ADDENDUM NO. 3

February 25, 2022

DOUGLAS MACARTHUR ELEMENTARY SCHOOL ADDITIONS, RENOVATIONS, AND RELATED WORK

Crown Point, IN 46307

ED103

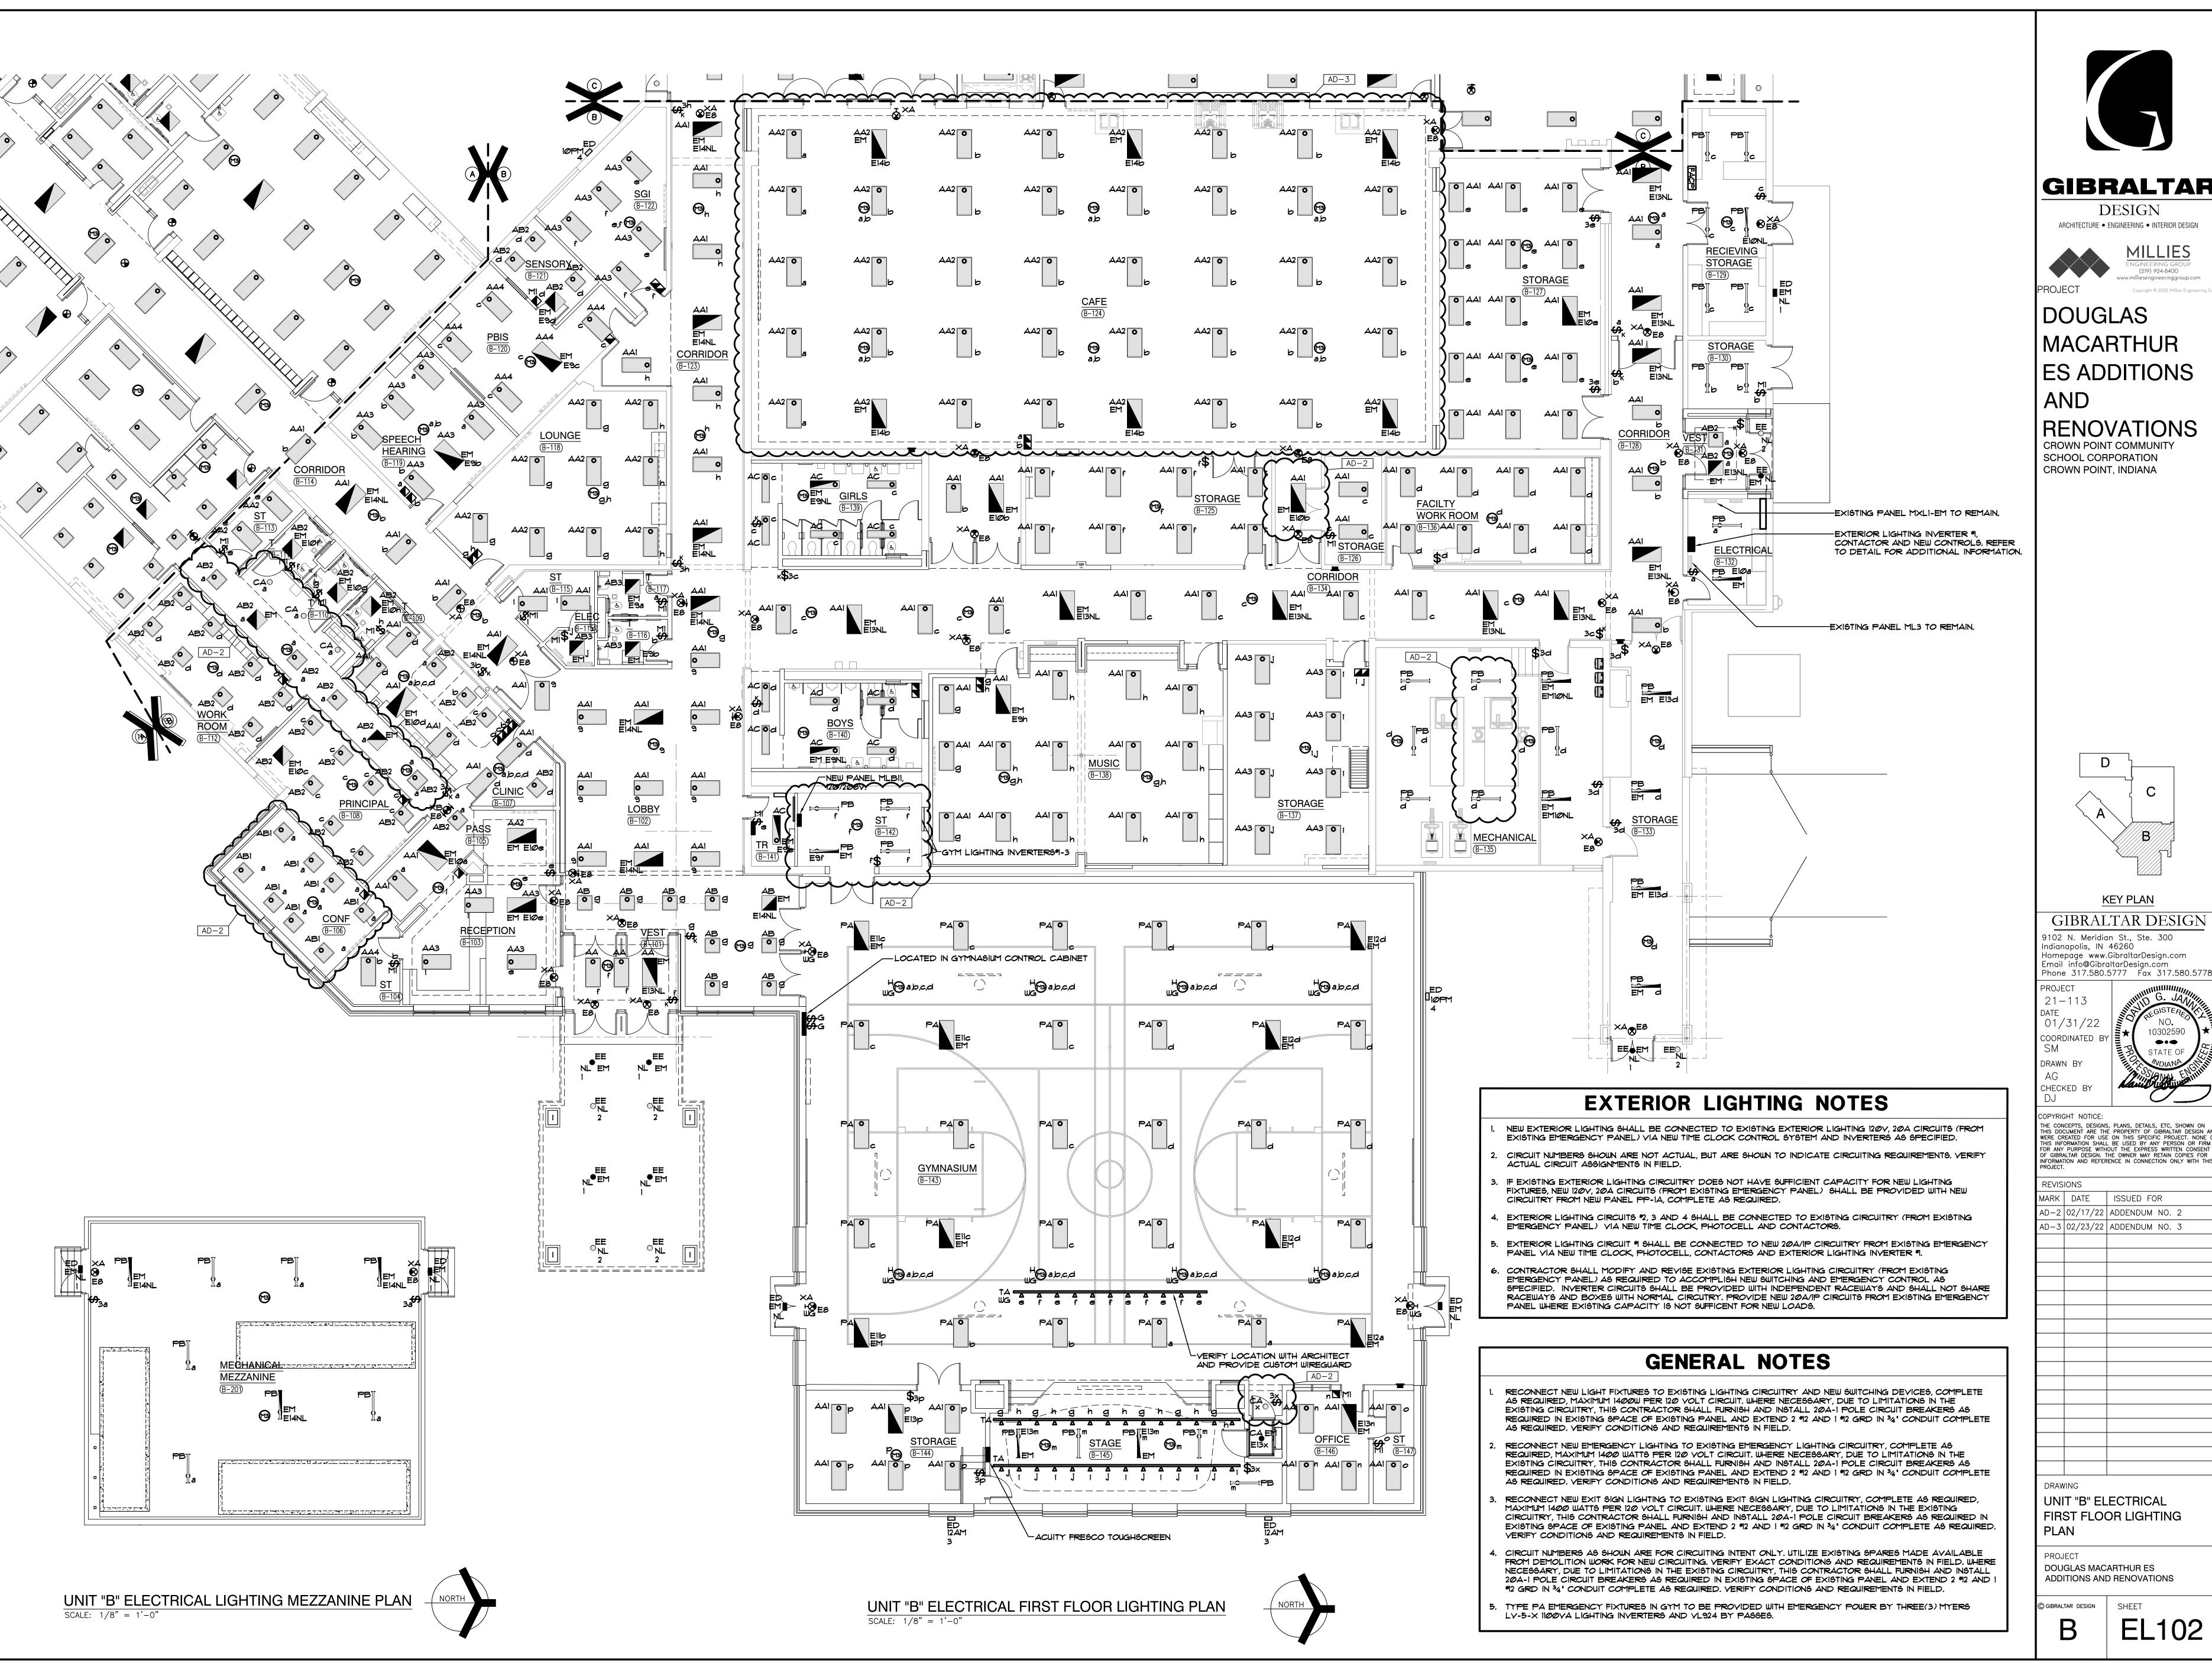
A. Refer to revised, full size drawing, included in this Addendum, for revised demolition floodlight to be removed and relocated.

EL102

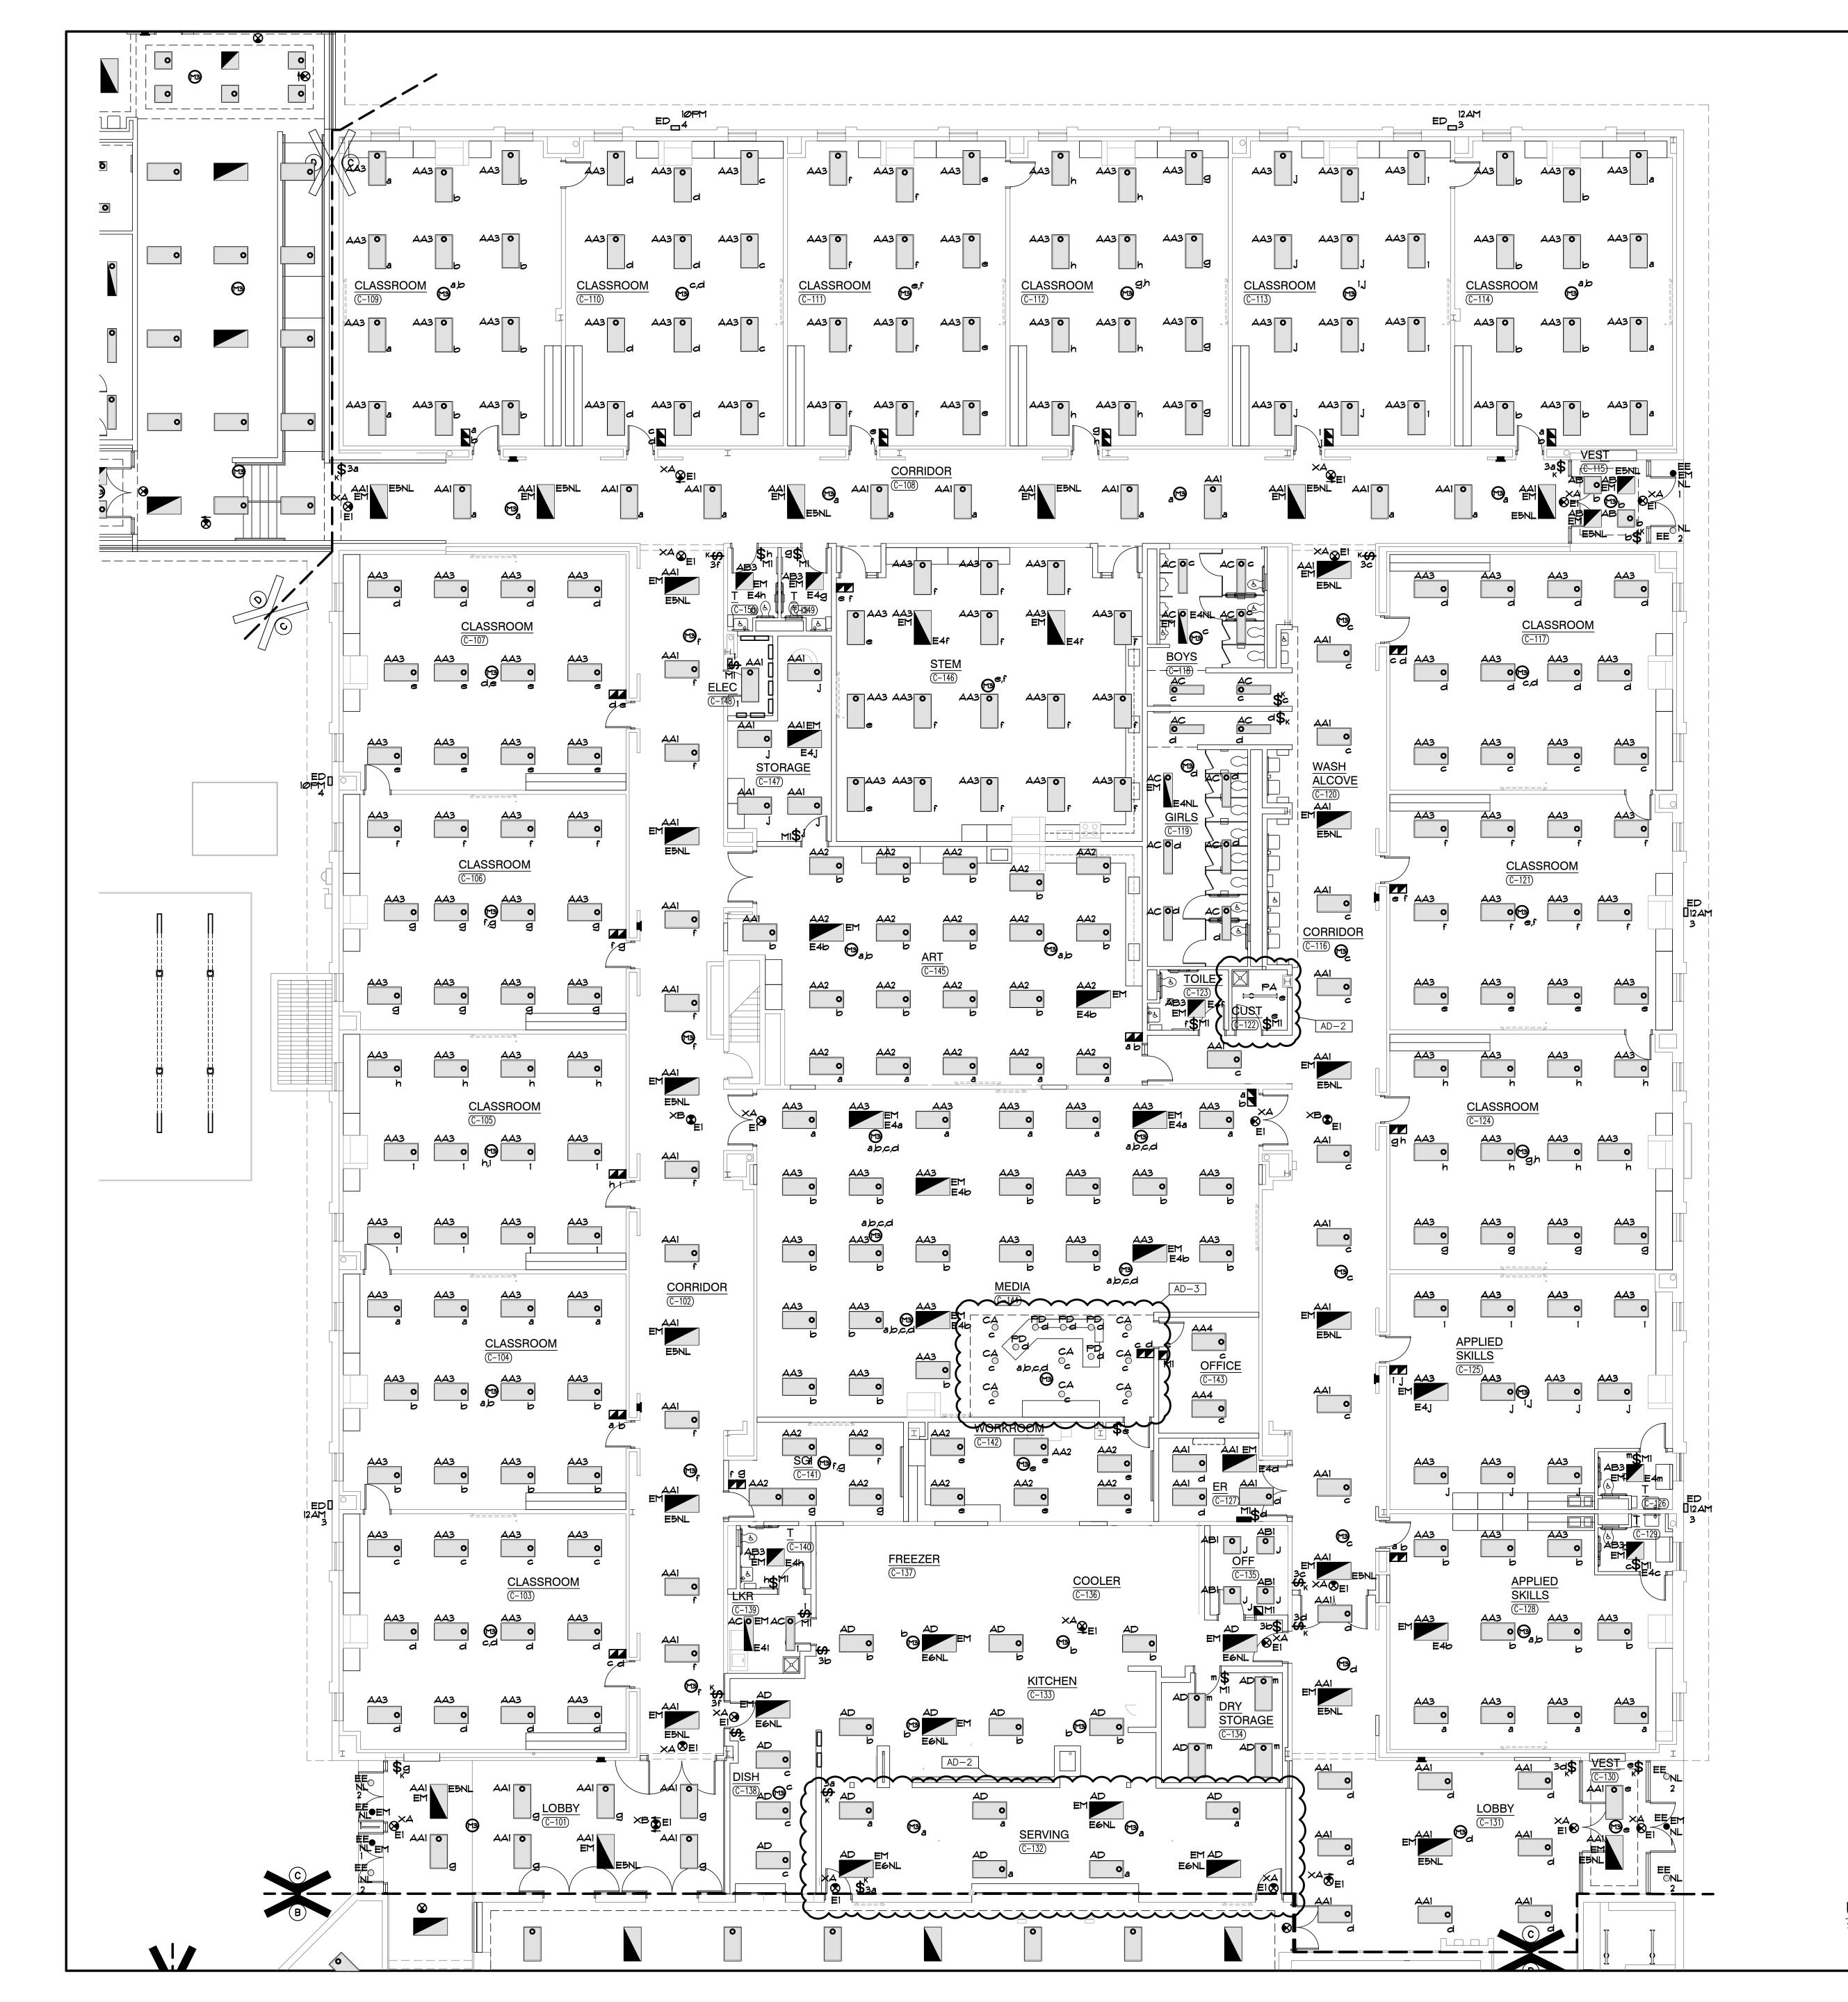
A. Refer to revised, full size drawing, included in this Addendum, for revised Café B-124 lighting.

SHEET EL103

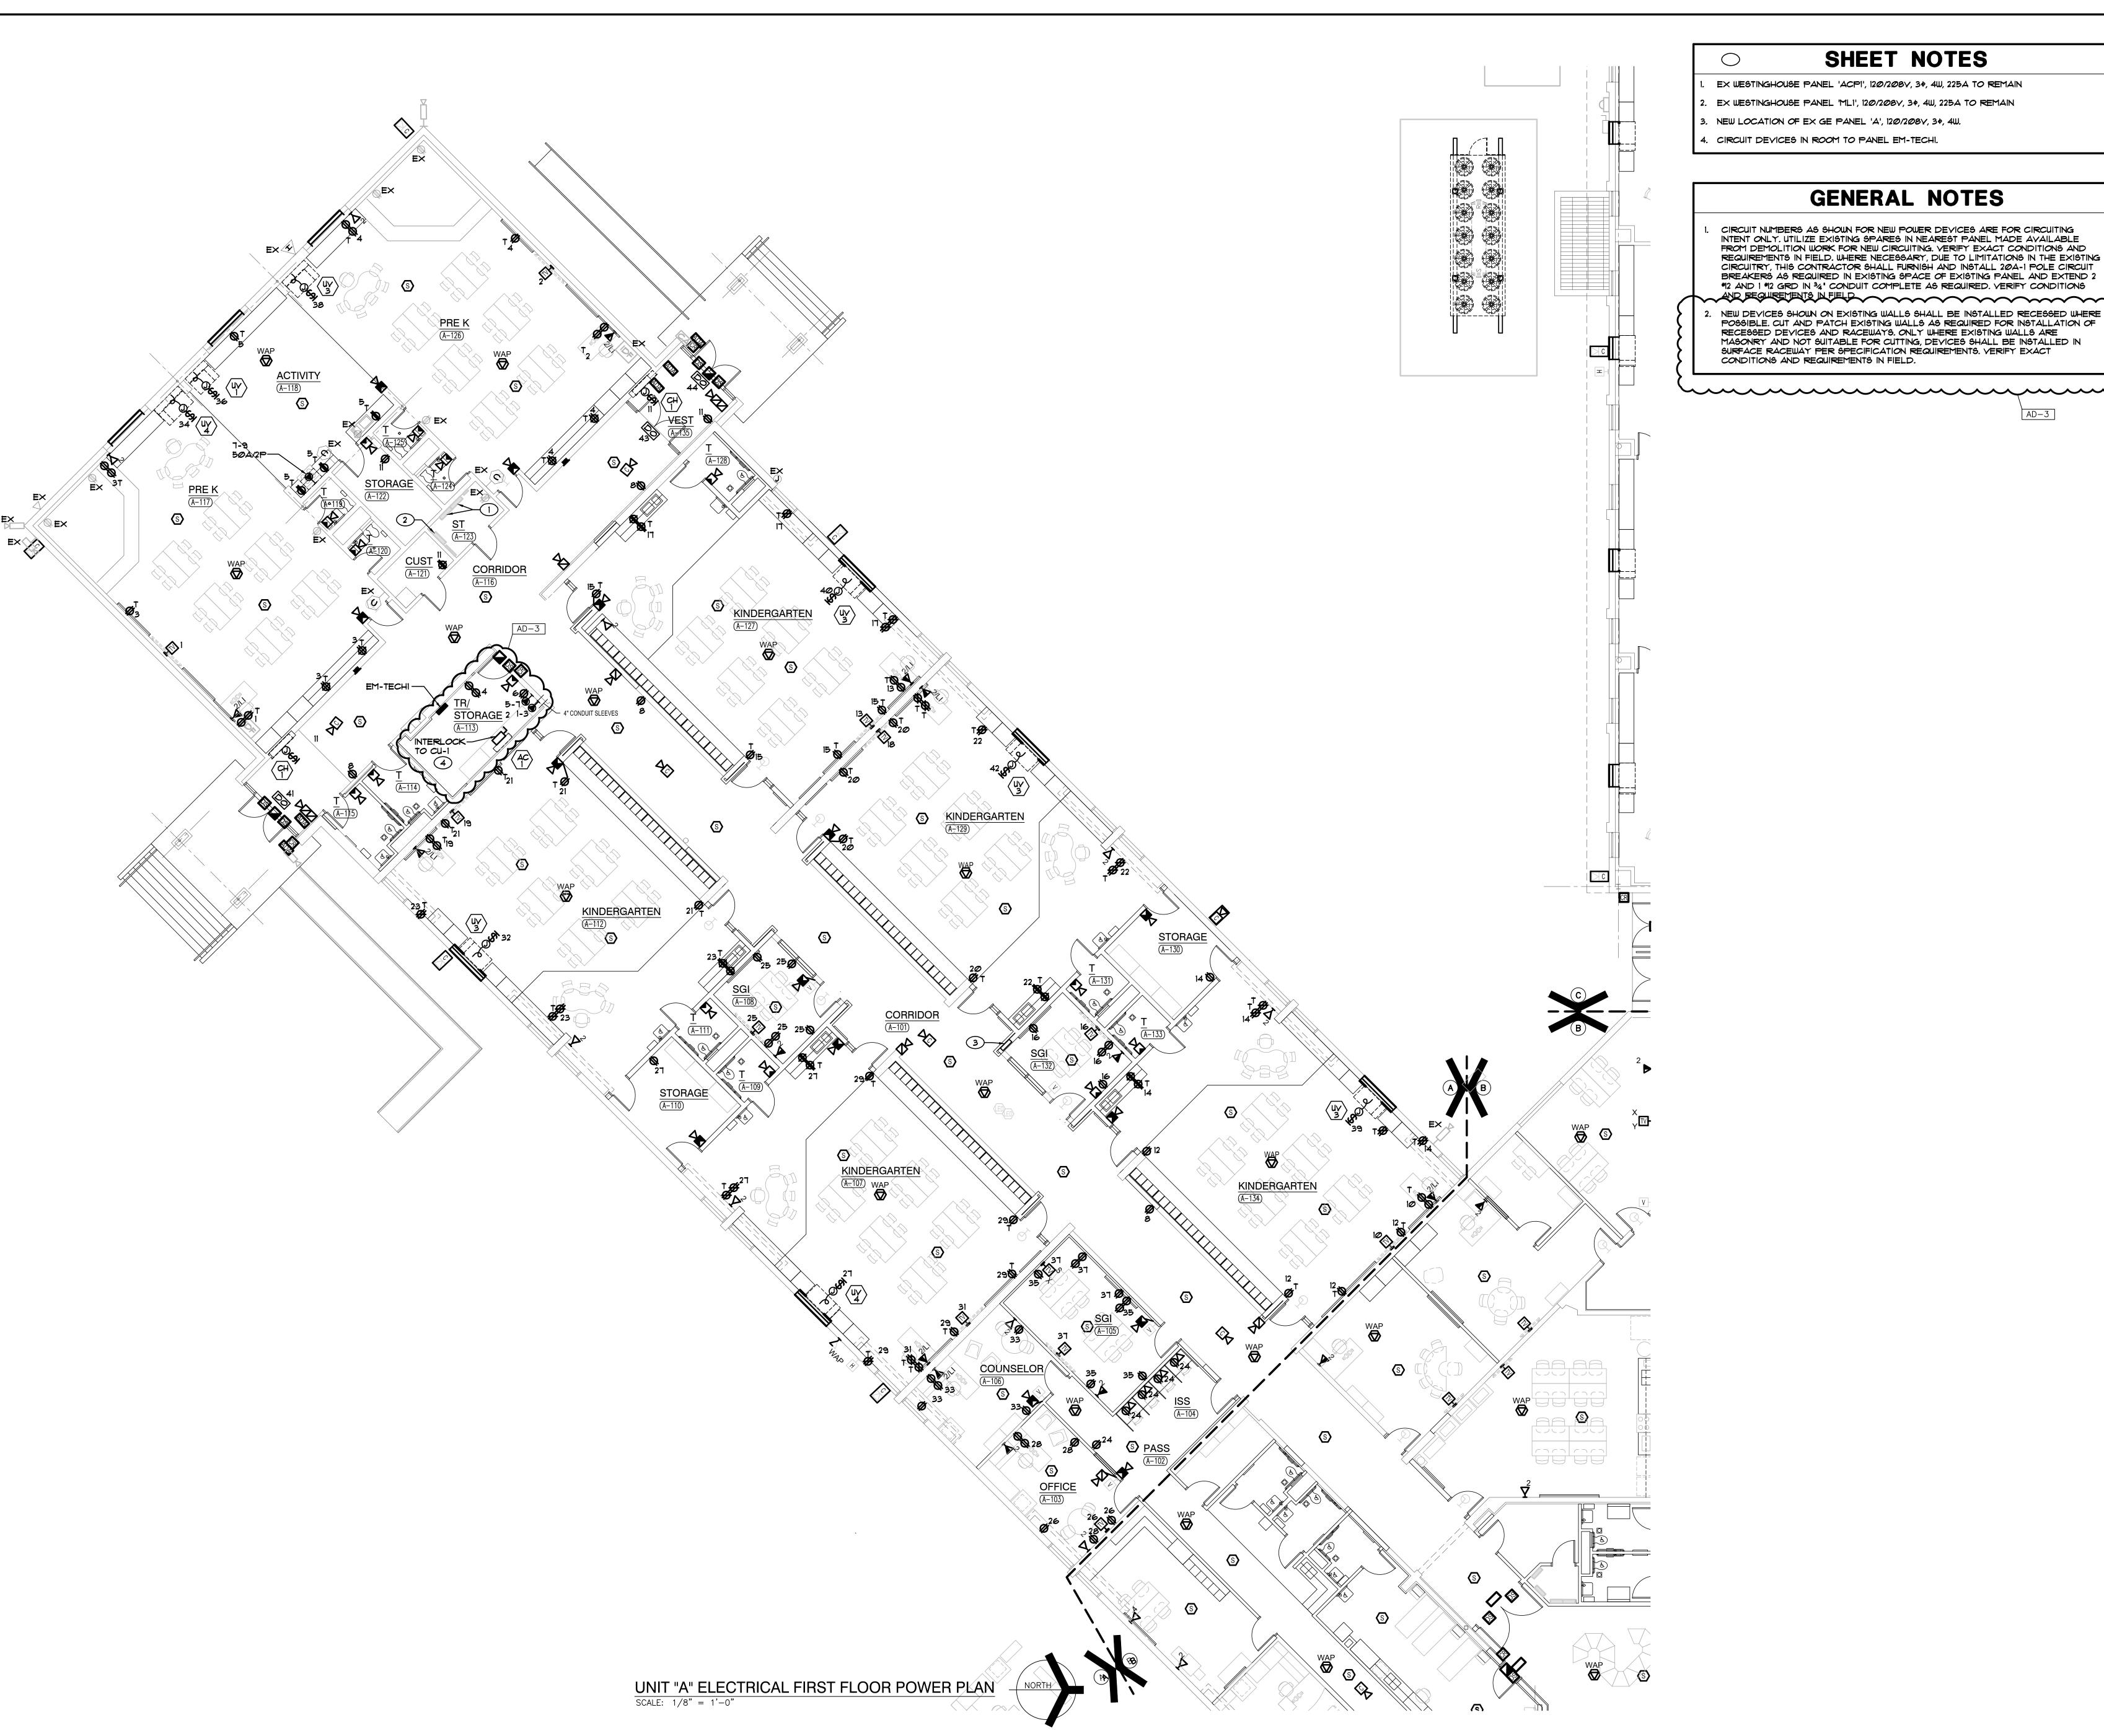
A. Refer to revised, full size drawing, included in this Addendum, for revised Media C-144 desk lighting.
